HISTORIC DISTRICT REVIEW BOARD REGULAR MEETING AGENDA

Agenda Item: APPLICATION FOR AN ALTERATION, HDRB #25-007, to consider an application for a Certificate of Appropriateness for an alteration to add an entry portico to the single-family residential building located at 706 Main Drive, Herndon, Virginia.

Subject: APPLICATION FOR AN ALTERATION, HDRB #25-007, to consider an application for a Certificate of Appropriateness for an alteration to add an entry portico to the single-family residential building located at 706 Main Drive, Herndon, Virginia

Resolution- to approve a Certificate of Appropriateness to permit an alteration to add an entry portico to the single-family residential building located at 706 Main Drive, Herndon, Virginia, located in the southeast corner of the intersection of Main Drive and Vine Street, and further identified as Fairfax County Tax Map 0162 04 0030B.

SEAL:	
SCALE:	1/4" = 1'-0"
SHEET TITLE:	Floor Plan
SHEET NUMBER:	A1.0

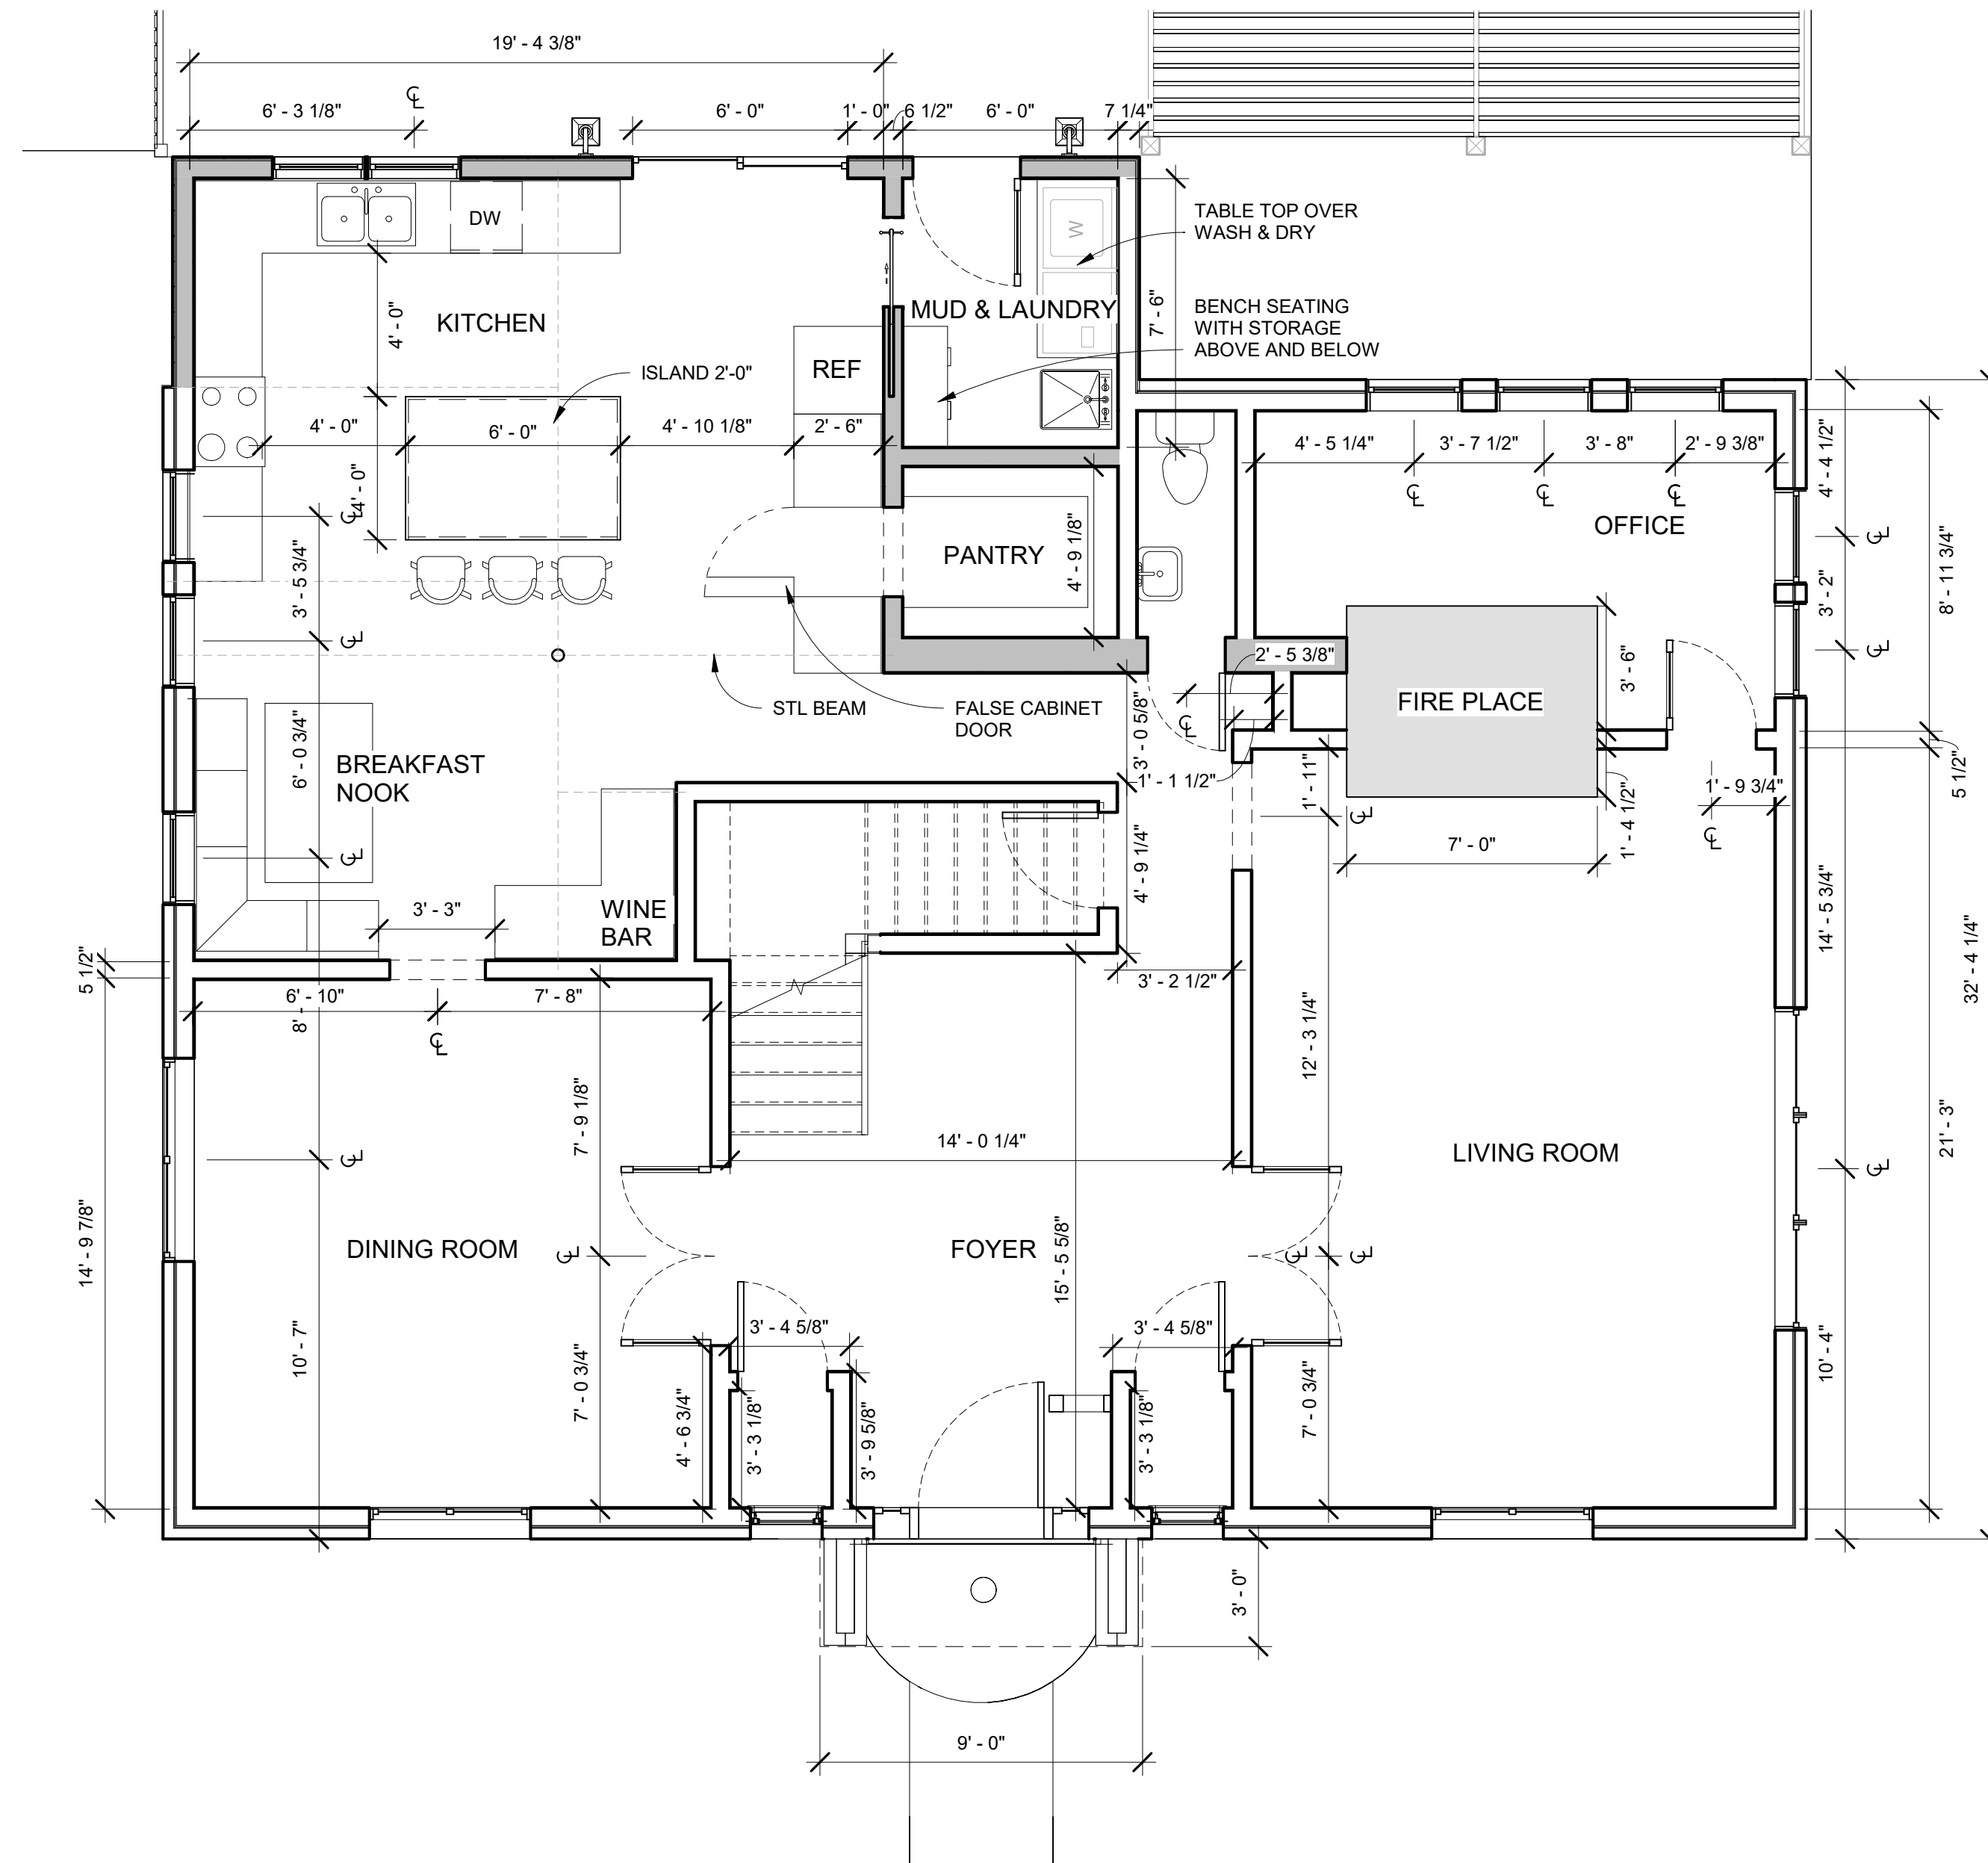
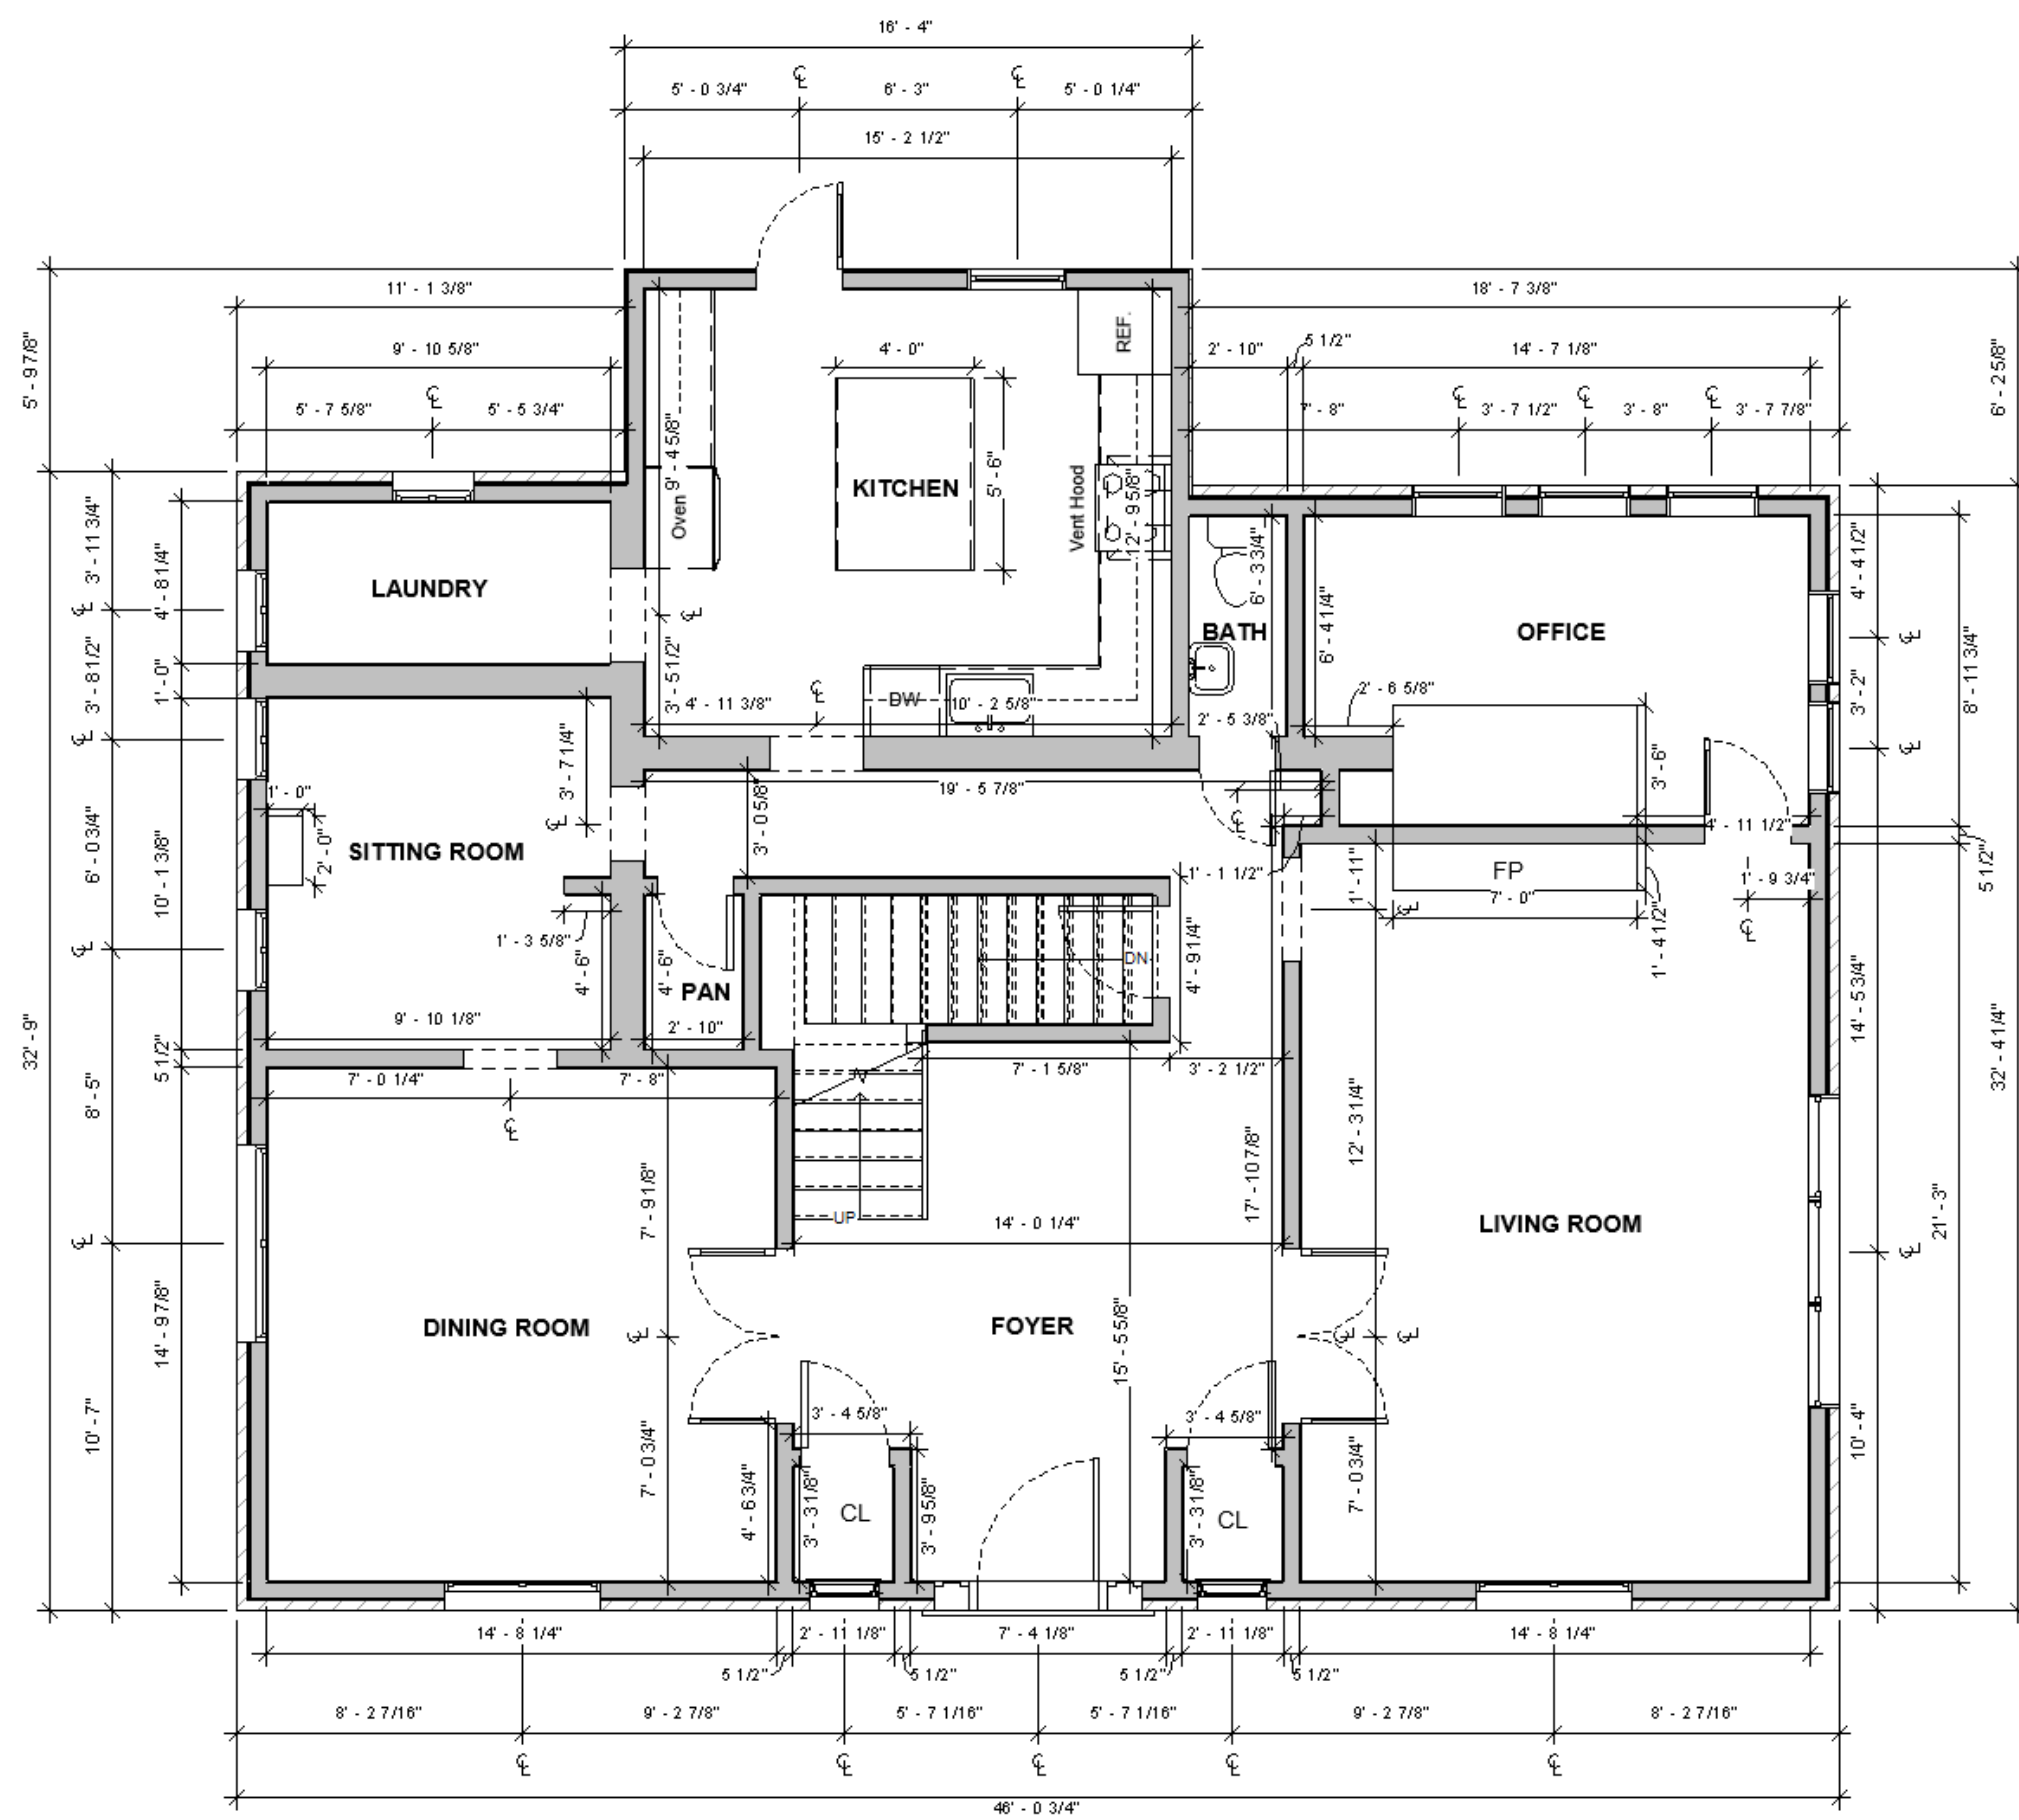
Note: Rear addition not included in the scope of work for HDR25-007. This work was reviewed and conditionally approved by the HDRB under a separate COA (HDR25-003).

SCALE:	As indicated
SHEET TITLE:	Left Elevation
SHEET NUMBER:	A2.1

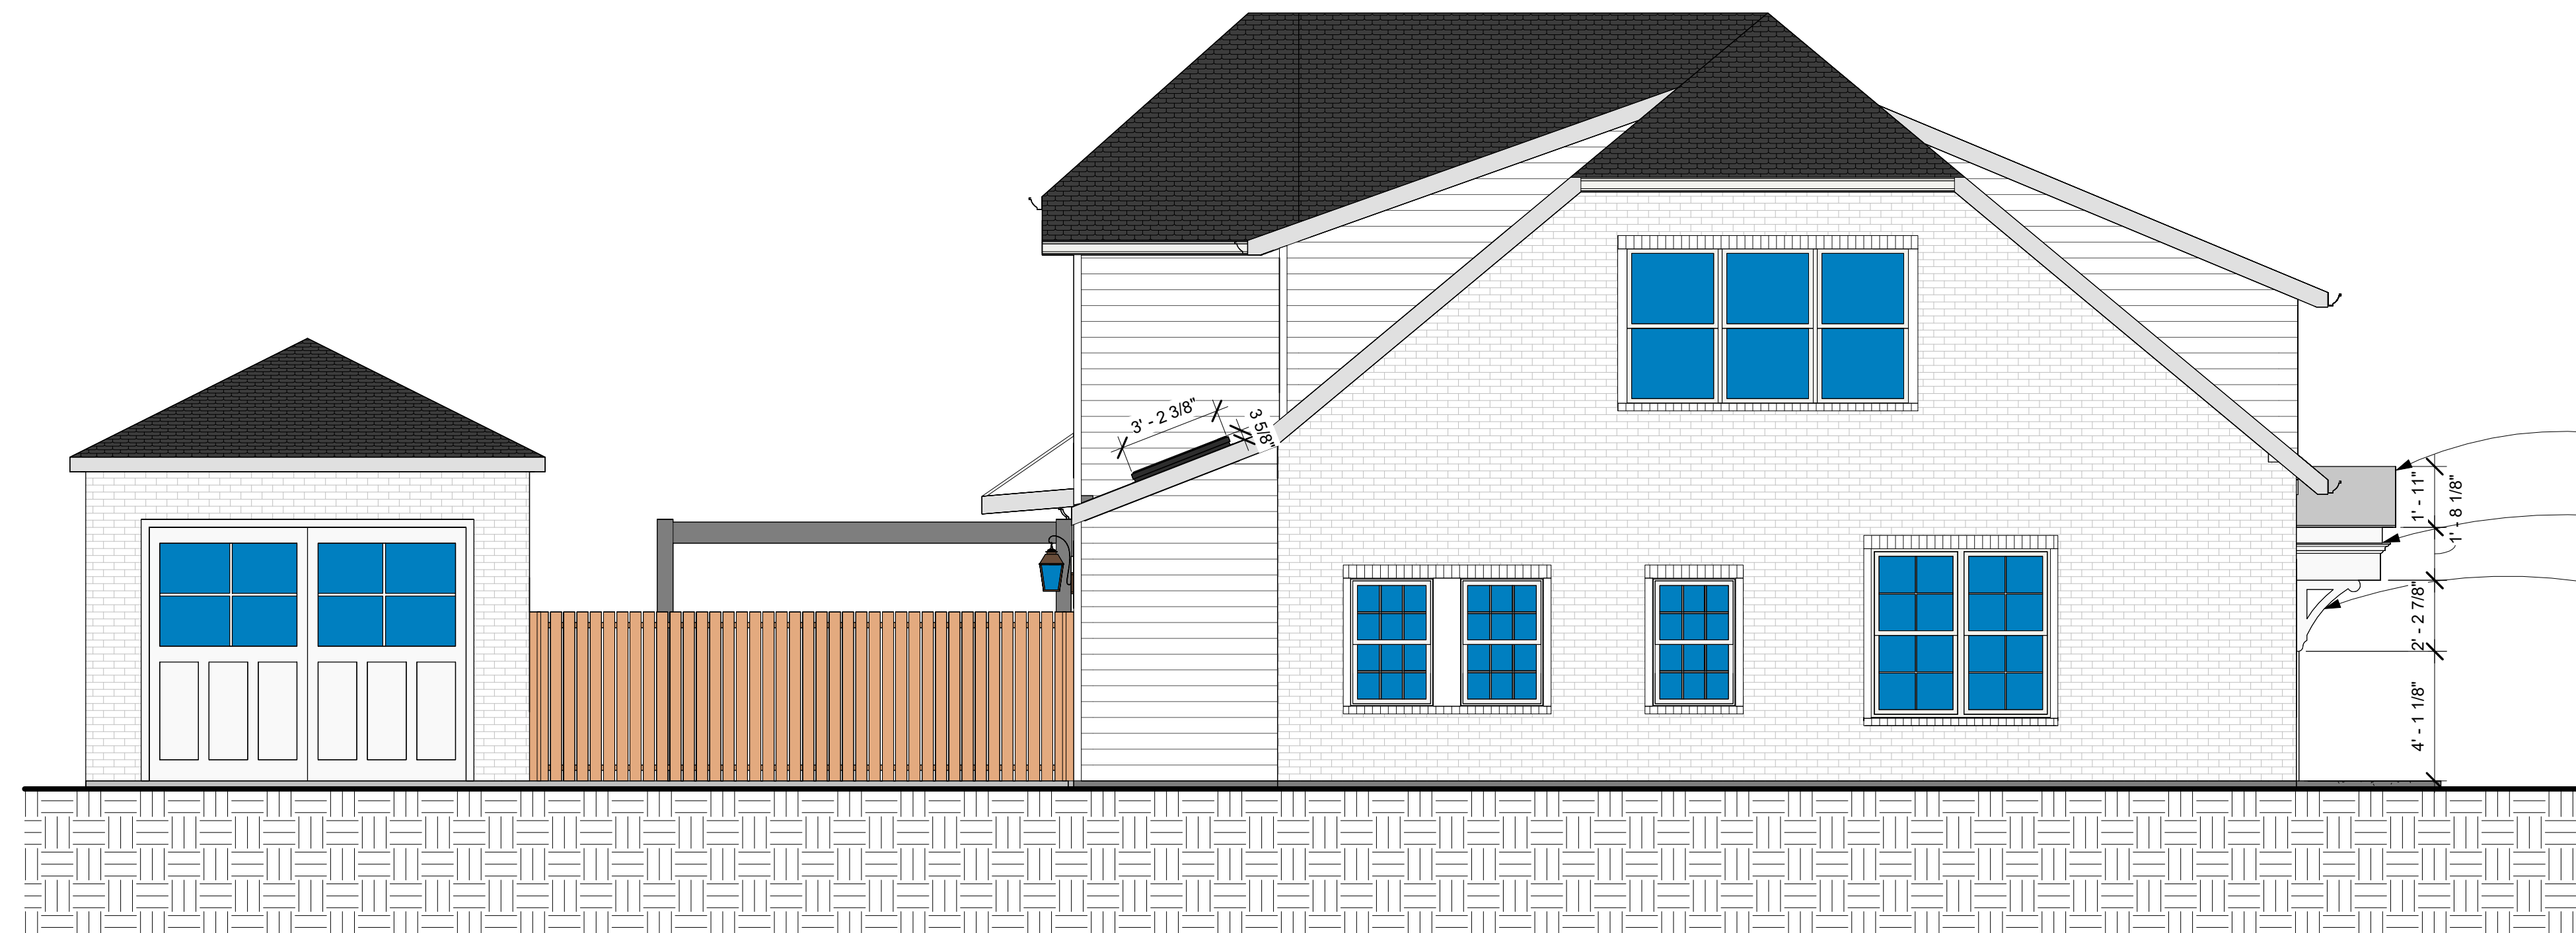
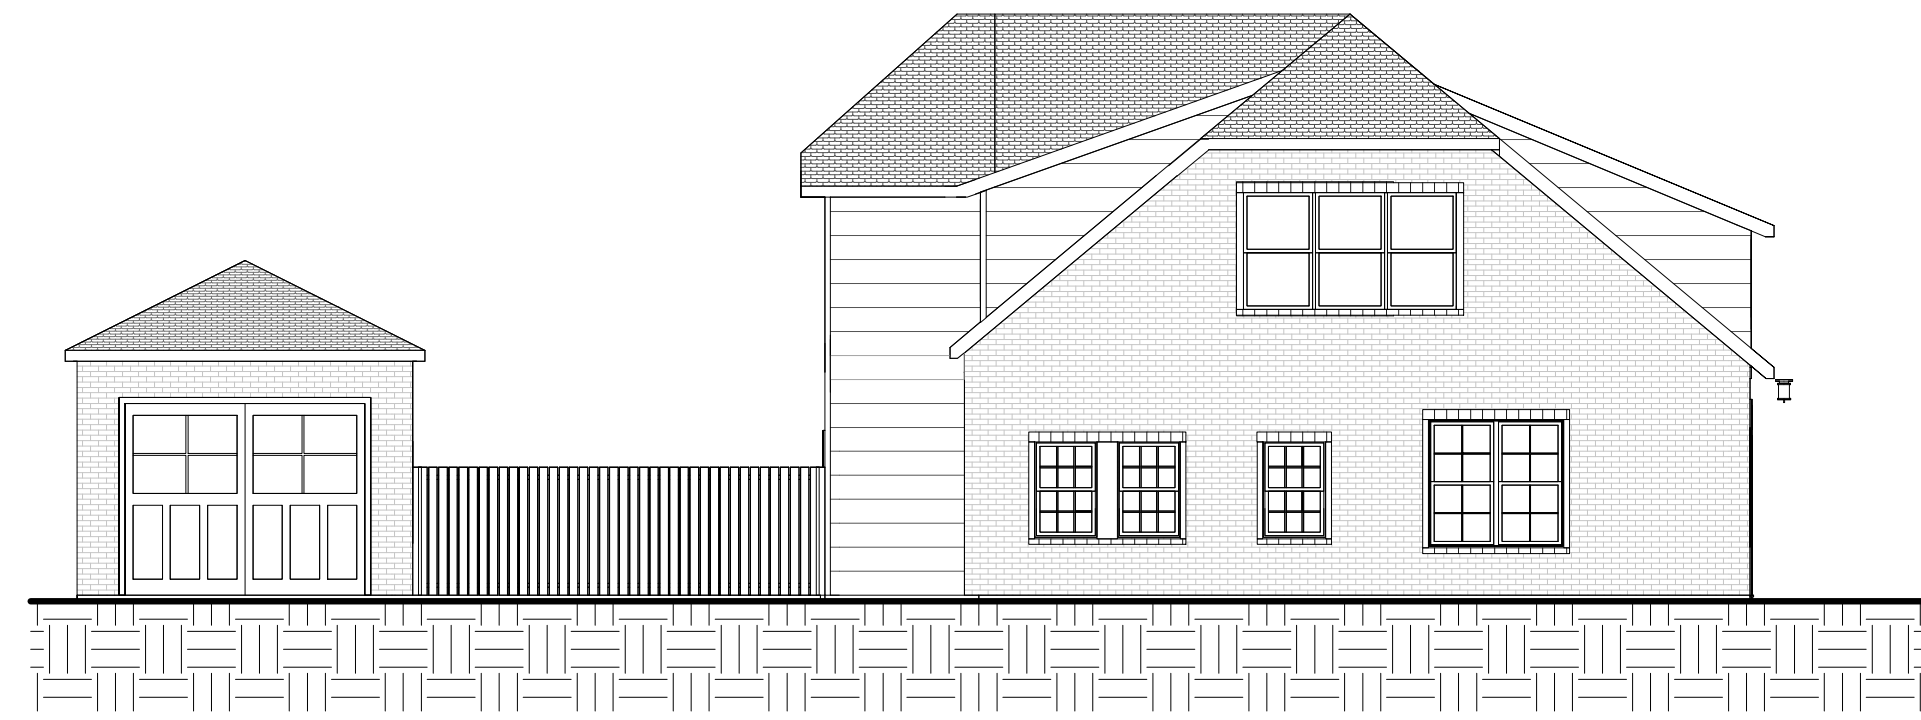
Note: Painting the yellow brick cladding of the dwelling and garage are not included in the scope of work for HDR25-007. Additionally, the applicant has changed the proposed roofing material to flat seam metal (see drawing A2.3).

- d. This approval does not include painting the yellow brick cladding of the dwelling or the garage.
 - e. The applicant shall coordinate with town staff prior to installation of the portico to provide in-process documentation to add to the case record demonstrating that the modification will be reversible and confirming that any necessary penetrations into the mortar joints are properly sealed.
